MOORE TREES

Site: 357-363 Crown Street, Wollongong NSW 2500

Re: Updated Arboricultural Impact Review of Heritage Item 6290 and associated impacts from the proposed DA-2023/156, 357-363 Crown Street Wollongong.

Plate 5: Image showing the fifteen (15) metre mark in relation to the canopy. P. Vezgoff

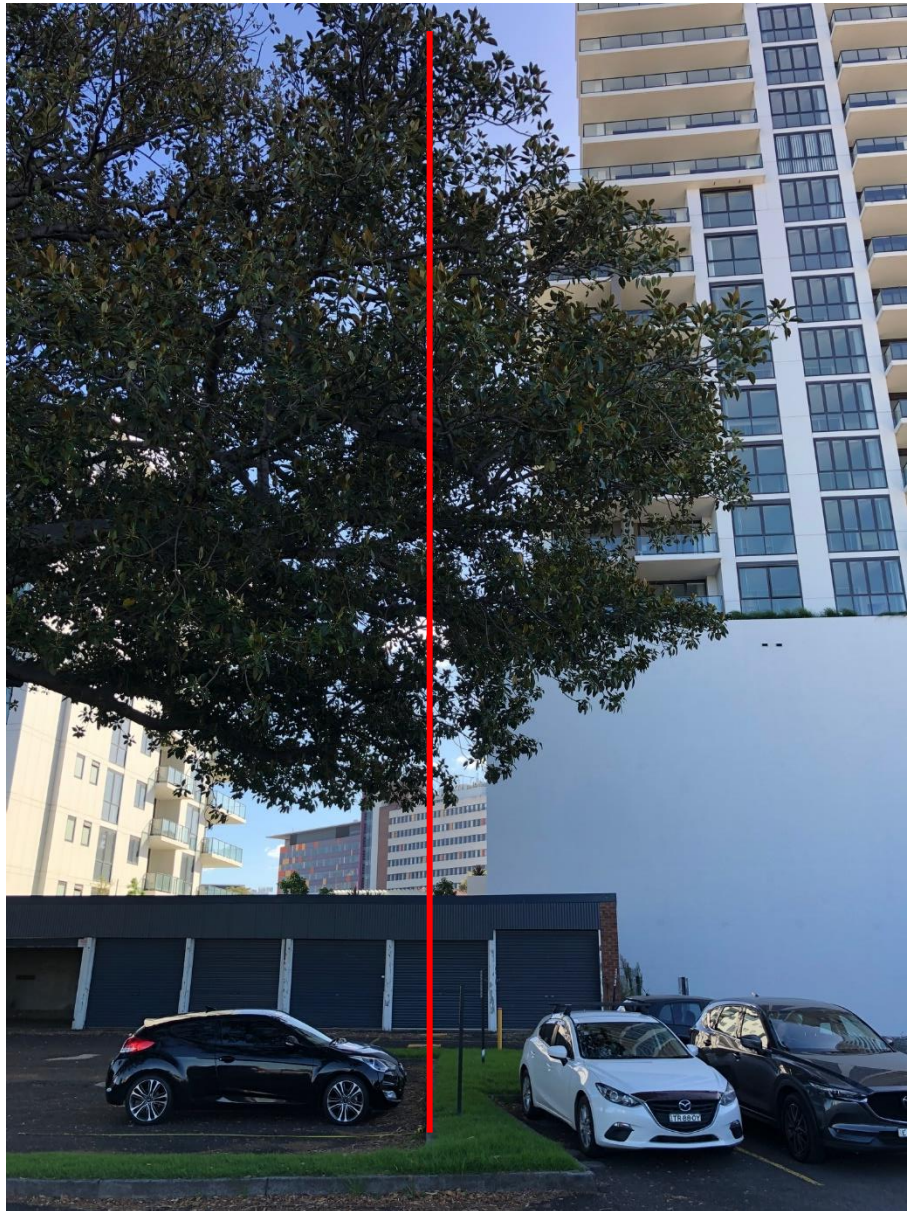
The Arborist Report by Seasoned Tree Consulting (STC) details the canopy spread as being symmetrical at 15 fifteen (15) metres, whereas the actual distances measured by myself are asymmetrical and were measured as radial distances of twenty (20) metres to the north, fifteen (15) metres to the south, seventeen (17) metres to the east and fifteen (15) metres to the west. As a result, the tree canopy is not drawn accurately on the plans and has only been represented as a symmetrical circle (Diagram 3 and 4).

Diagram 3: Part plan showing lawn under most of the northern canopy. To the south is car park associated with an adjoining property (Conzept landscape Architects).

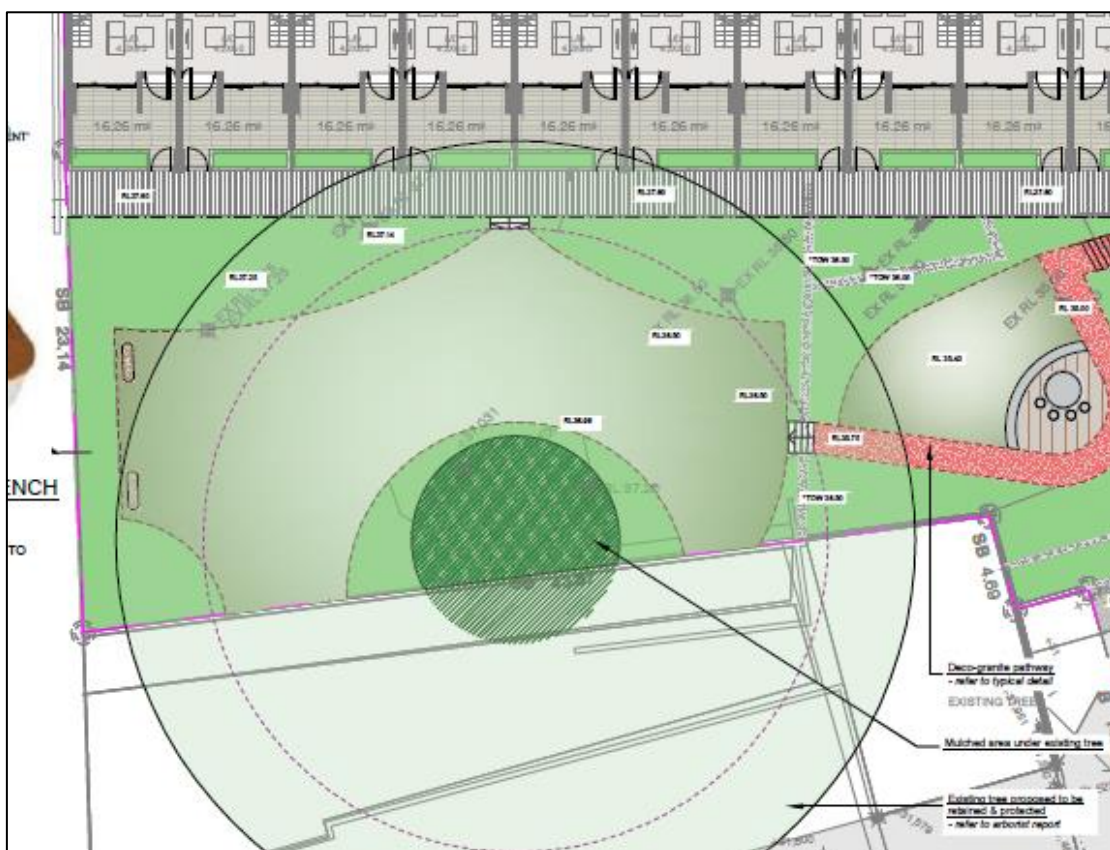
4. ASSESSMENT OF UPDATED PLANS AND DOCUMENTS: The works proposed within the TPZ include the demolition of all existing hard surfacing, basement excavation and multi-level car park construction. The previous landscape design of the area directly below the tree included stepping stones, turfing, planting, seating and a timber deck (Diagram 1). The updated landscape design by Conzept Landscape design shows most of the TPZ area in relation to the new works will be lawn (Diagram 3).

The updated landscape design, under Tree 6, will have a greater impact than the previous plan, that incorporated more garden areas to limit human traffic and garden beds, which would have helped with better soil health and condition. It will be extremely unlikely that any lawn will grow within such a high shade area. The required lawn management practices (mowing) will create ongoing compaction issues to the roots of this tree.

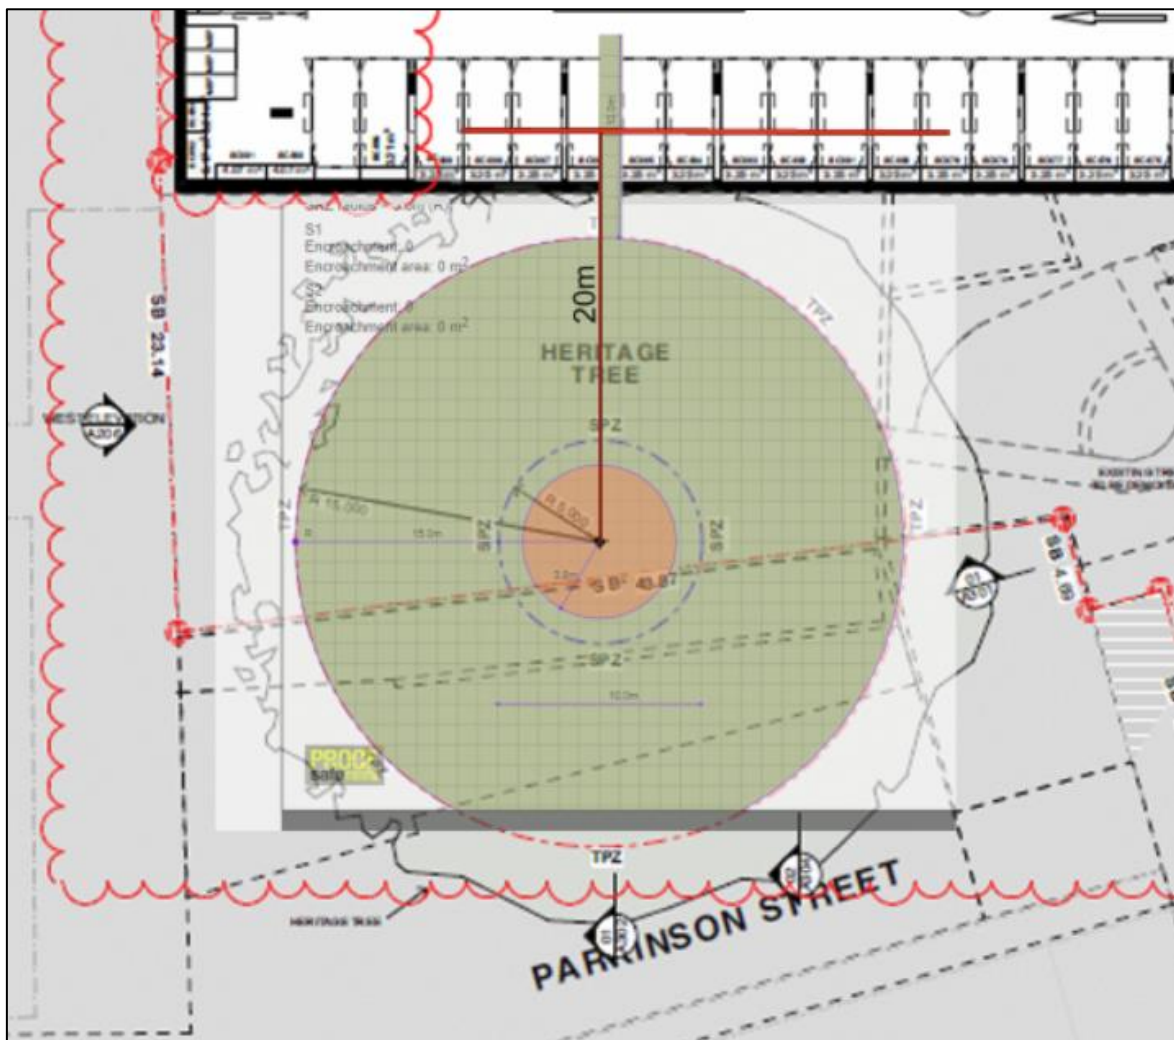
I have adapted part plan of sheet A101 to demonstrate this issue in Diagram 4. I have overlaid a scale chart to illustrate the twenty (20) metre canopy span in relation to the basement excavation. This clearly shows the canopy will be impacted by piercing/shoring works. These machines, required for these works, are quite tall and require adequate vertical clearance for safe and proper operation. Also see Diagram 5.

This may be true for the upper storeys of the proposed building design however the construction of the basement will almost certainly conflict with the canopy of this tree.

Diagram 5: Part plan of Drawing A304 showing the canopy spread 20m does not match the drawing. This section drawing also shows the basement in relation to the canopy in terms of the drill rig conflicting with the canopy.

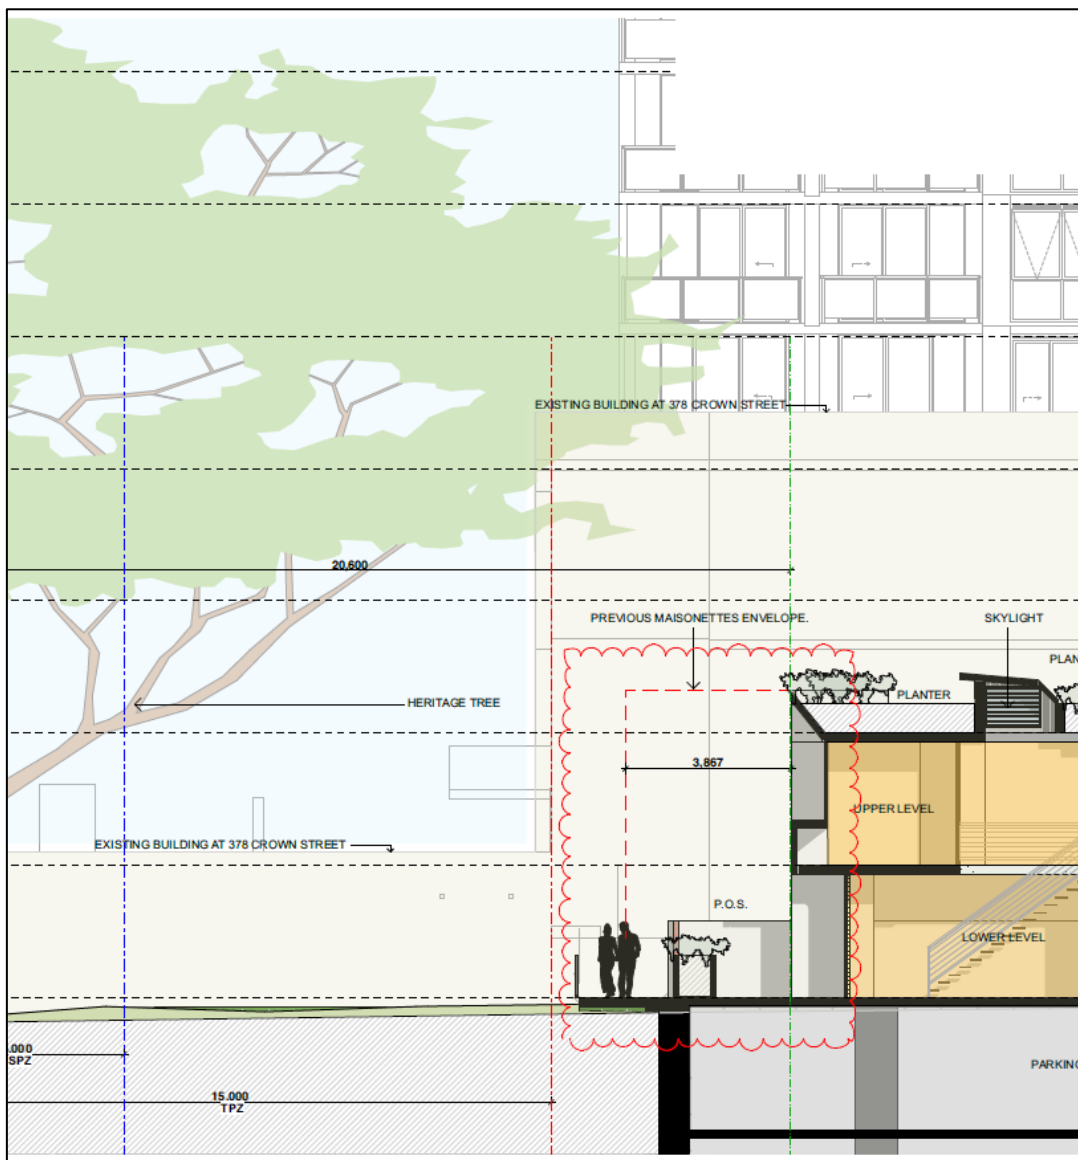
- c) The basement excavation will require a large size drill rig that will be used to shore the wall sides. Based on the plans provided this equipment required (the drill rig) is likely to clash with the northern portion of the canopy. The current basement design will impact the canopy of this tree.

- d) The tree canopy is still not shown accurately on drawings i.e. still drawn as a symmetrical circle. Diagram 5 shows the inaccurate section drawing of the canopy.
